CREATION DATE : 27-MAR-12
BID NUMBER: 7449530,1
TITLE: FURNISH & INSTALL FIRE ALARM SYSTEM AT (5 GROUP HOMES), BHDDH
BLANKET START : 01-MAY-12
BLANKET END : 30-JUN-12
BID CLOSING DATE AND TIME:10-APR-2012 11:00:00

ADDENDUM # 1

BID #7449530

MANDATORY PRE-BID MEETING

1463 Main Rd

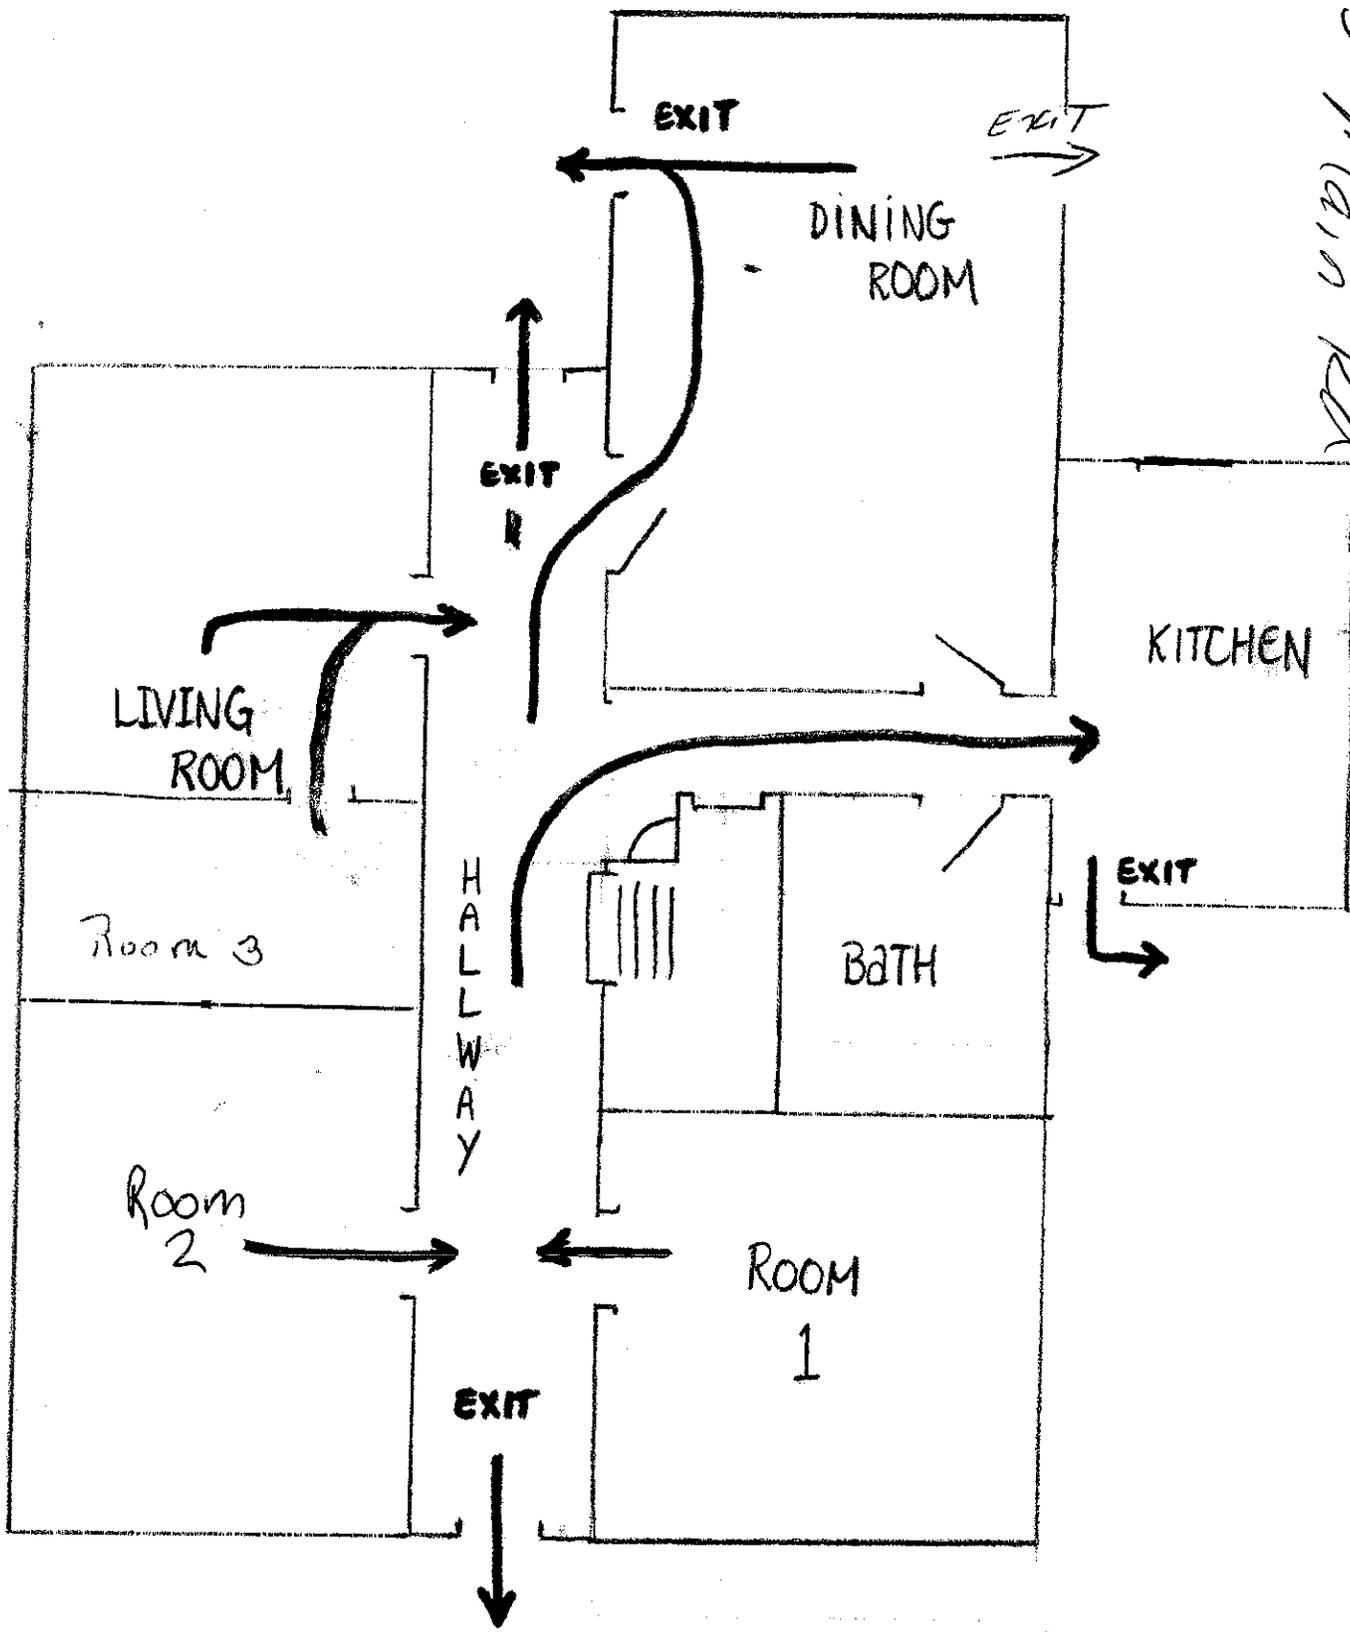
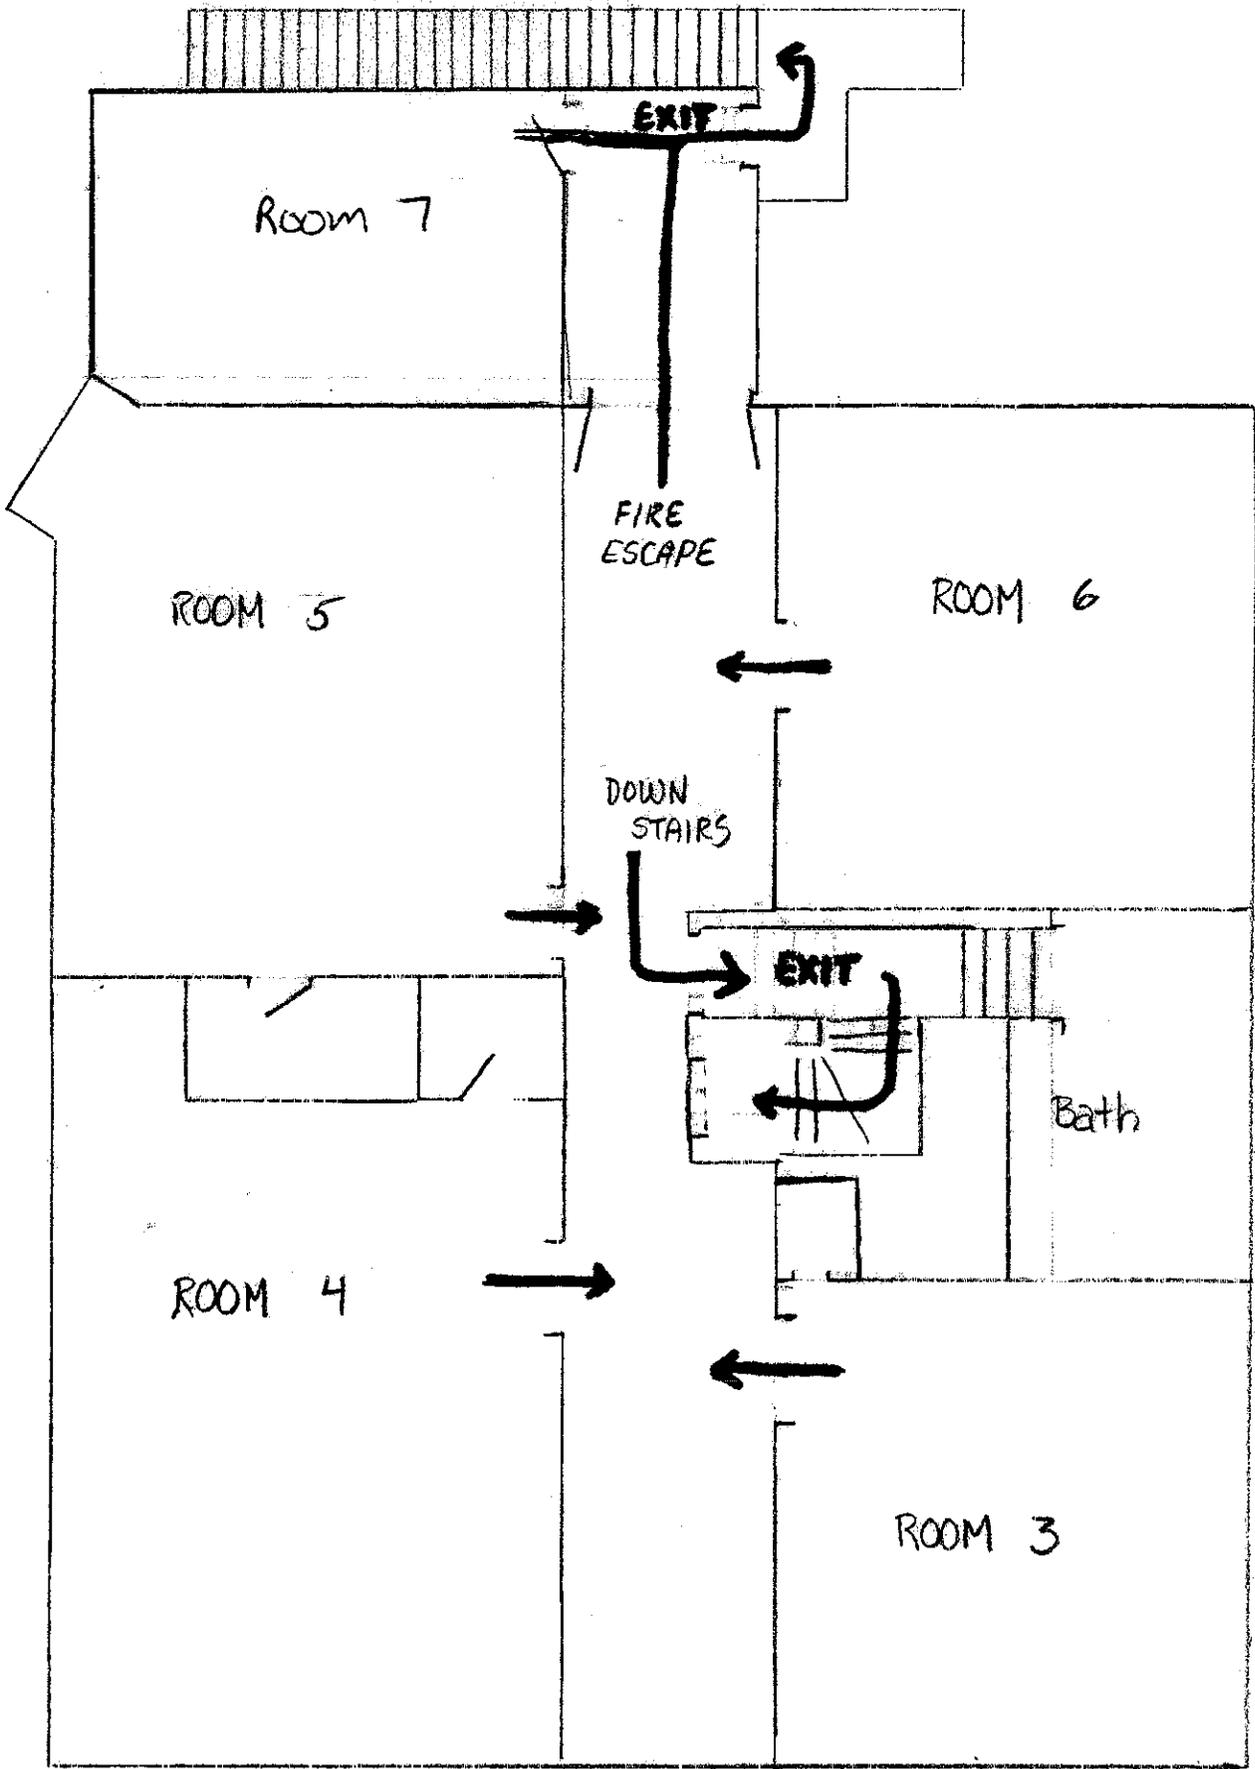
9. FULLY DIMENSIONED PLANS ARE REQUIRED FOR PLAN REVIEW
10. FOR 1463 MAIN ROAD, TIVERTON – THE SFM & BHDDH ARE REQUIRING A PULLSTATION AND EXIT SIGN AT THE NORTH EXIT (FACING THE 3 BEDROOM COTTAGE) OUT OF THE DINING ROOM. ALSO, AT THIS LOCATION, THE FIRE ALARM SYSTEM WILL BE REQUIRED IN THE MAIN HOUSE ONLY.

11 Question received by email: Will we be responsible for the removal of the existing fire alarm at 1463 Main Road? **Yes. It is the responsibility of the vendor to remove the existing fire alarm system. However, there must be fire alarm coverage in the home at all times. Once the new system is installed, tested and accepted, then the old system must be removed in its entirety.**
